Application No: 22/2185/FH

Location of Site: Garage Block Adjoining Southwinds, Cliff Road, Hythe CT21 5XW

Development: Demolition of existing garage and the construction of 1no. single storey dwelling including parking and landscaping

Figure 2: Proposed elevations

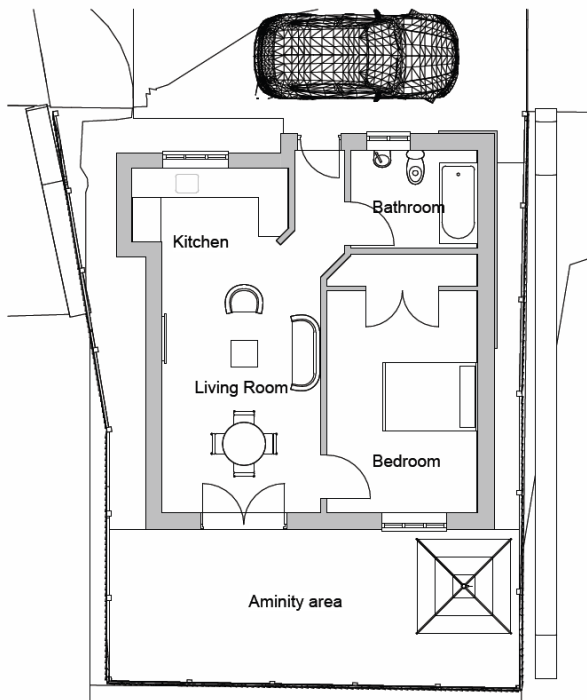
- 7.7 In terms of scale and design, the surrounding development is characterised by traditional dwellings with a strong pitched roof vernacular. The proposed dwelling would have a large, hipped roof with 2.6 high eaves, and a pitched projection with its gable to the front elevation. The dwelling would extend beyond the established building line of Linden (west) and Southwinds (east), resulting in a dominant feature which is not characteristic of the area and would fail to maintain the visual quality of the street. Although the proposal differs the previous refusal under application 22/2186/FH (as listed within the proposal section above), the amendments are not considered to be sufficient to overcome the previous concerns under application 21/0879/FH.

- 7.8 The roofscape would include a hipped roof, a pitched roof, and a flat roof with a roof lantern. The mix of these roof forms at various heights on the front elevation are considered to result in a cluttered and disjointed front elevation which is considered to appear out of character in the context of the area. Officers are also concerned that the proposed materials, which would include a mixture of brick, weather boarding and render in a relatively small space would result in a design which appears cluttered, disjointed and overly busy with regards to the elevational treatments.

Figure 4: Proposed Site Plan

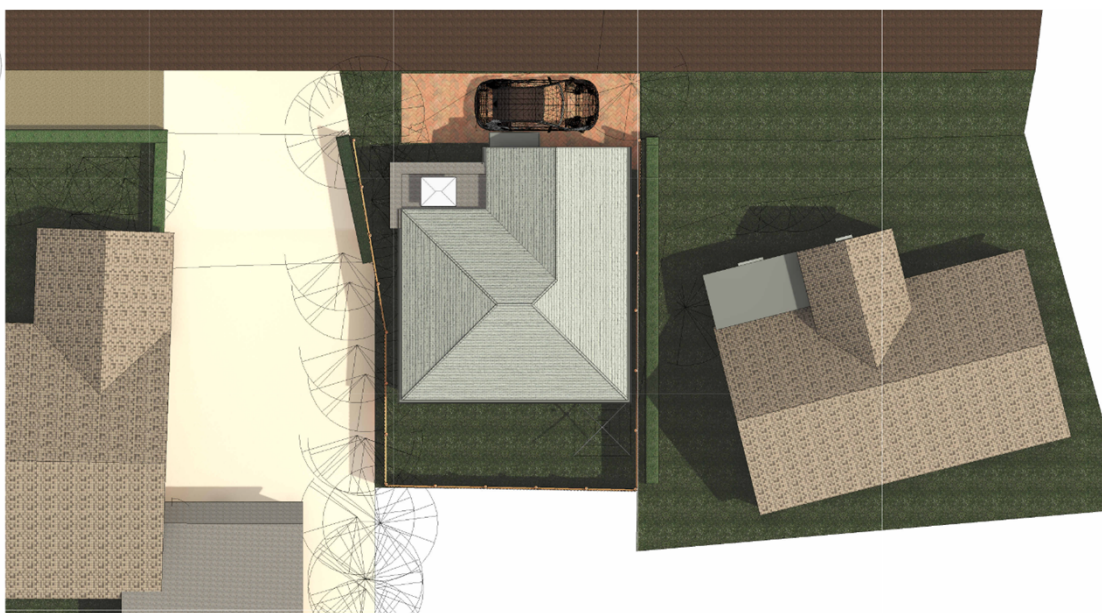
- 7.4 As previously, the footprint of the proposed dwelling and building envelope would continue to cover a large proportion of the application site with only external space for a very small rear garden (8.6m x 3.3 m) and parking for one car to the front.

- 7.5 If approved, the development would retain a gap of approximately 0.5 metres from the eastern boundary and 0.8 metres from the western boundary at its closest point. Despite the amendments following the previous refusal (21/0879/FH), which include bringing the built form in from the eastern boundary and closer to the west, these changes are not considered sufficient to overcome the previous reason for refusal relating to the layout. The development would continue to present a cramped and over intensive development that would be out of keeping with the prevailing form and pattern of development and appear squeezed in a very restrictive plot, in between the two neighbouring properties and representing overdevelopment of the plot. The proposal would also be positioned forward of the other properties on the street scene (as seen in Figure 4: Proposed Site Plan), which would appear incongruous with the existing development along the road.
